DEVELOPMENT APPLICATION

EXECUTIVE SUMMARY

Primary Property	100 Eton Road LINDFIELD NSW 2070
Lot & DP	Lot 1 DP 1151638
Proposal	Construct 2 residential flat buildings comprising 129 units and basement car park and associated site works - Precinct 3
Development application no.	DA0346/12
Ward	ROSEVILLE
Applicant	Defence Housing Australia
Owner	Defence Housing Australia
Date lodged	22/08/2012
Issues	Solar access; number of stories within development; basement projection; unit configuration; length of buildings
Submissions	Yes
Land & Environment Court Recommendation	N/A
Assessment Officer	Approval Adam Richardson

F SECTION F
Scale 1:200

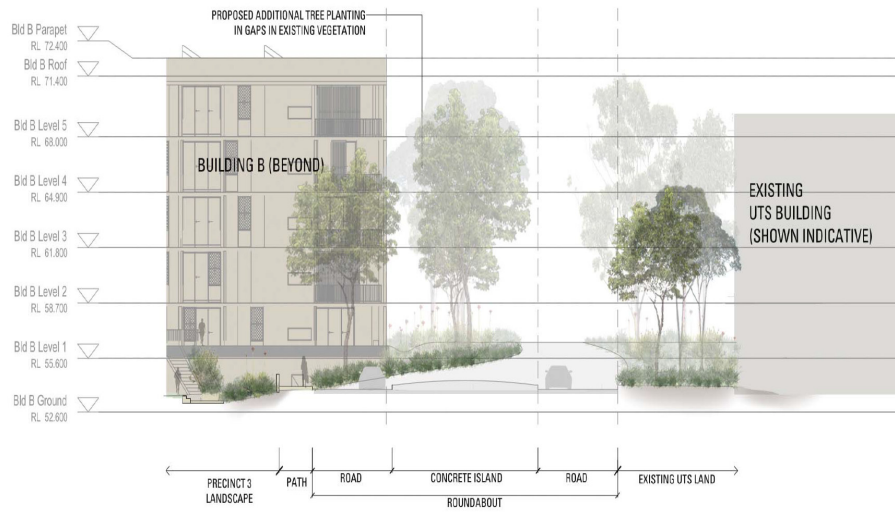
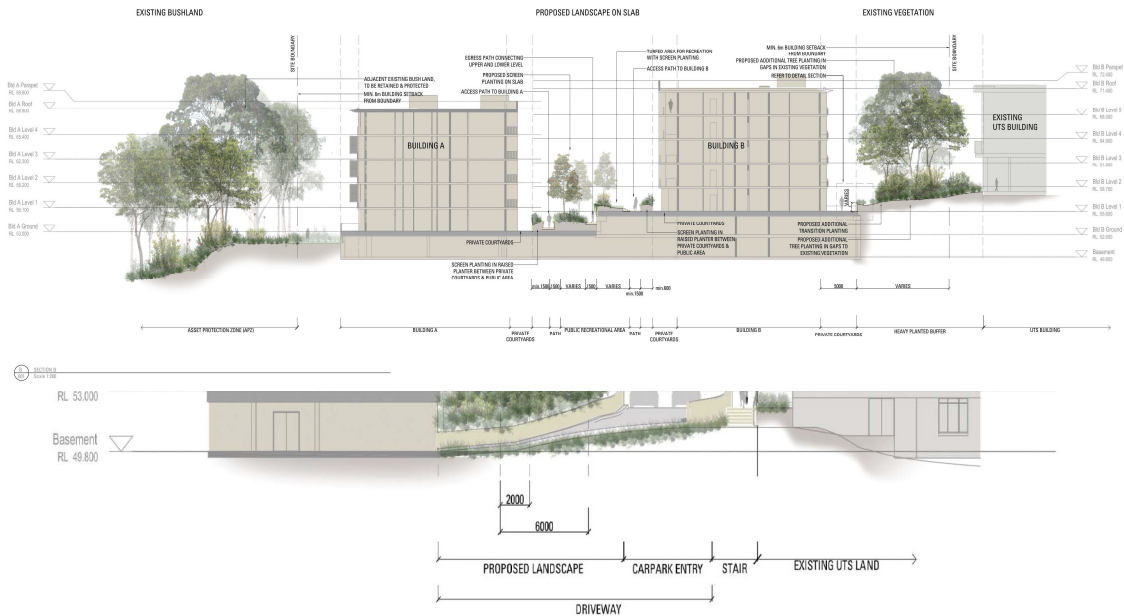
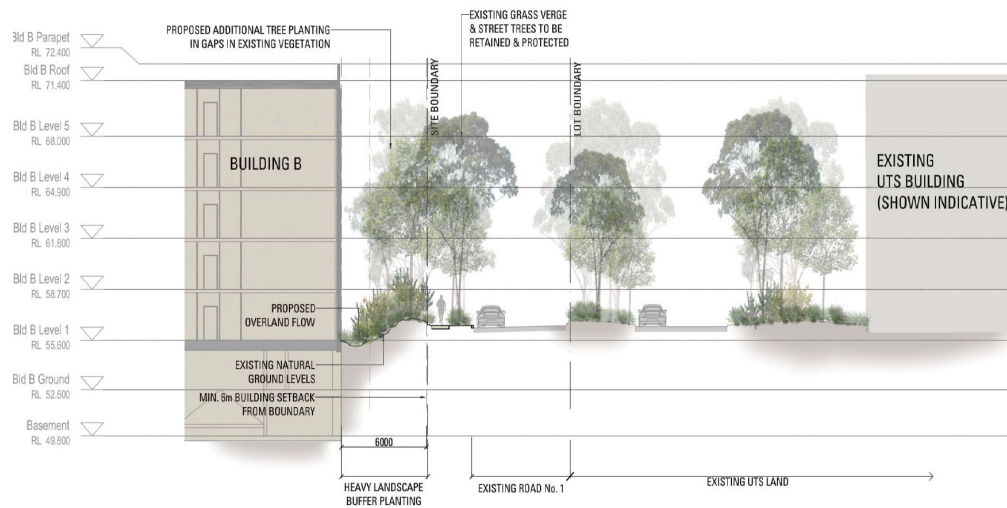
The architectural submission made to Council has been supported by details sections and elevations which illustrate the relationship between the proposed development and University buildings. Screen landscaping is shown, noting the overarching requirement for the site to be managed as an inner protection area with respect to bushfire, limiting the ability of the development to be completely screened from the University. The below extract from the architectural plans highlight this:

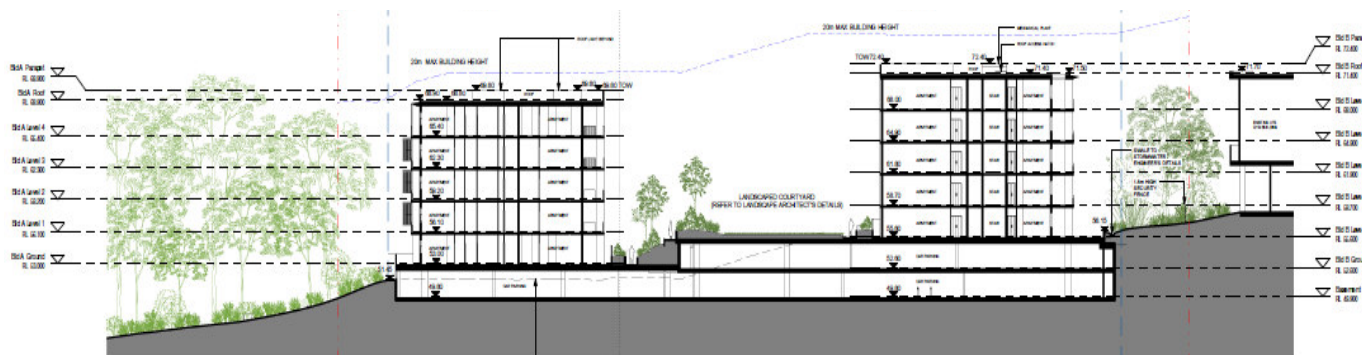
The development, due to prevailing site levels, technically results in a 7 storey building with regard to the definition of a storey contained within the UDGs. This is as a consequence of both levels of the basement protruding more than 1m above the prevailing ground levels within the area of the site to be developed (noting that these levels vary significantly across the building footprint due to existing improvements such as the tennis courts).

The extent of variation is illustrated in the below diagram:

Both the Concept Approval and the UDGs limit the development in this section of the UTS Ku-ring-gai campus to 5 storeys, with this supplemented by a maximum building height of control of 20m under the KPSO.
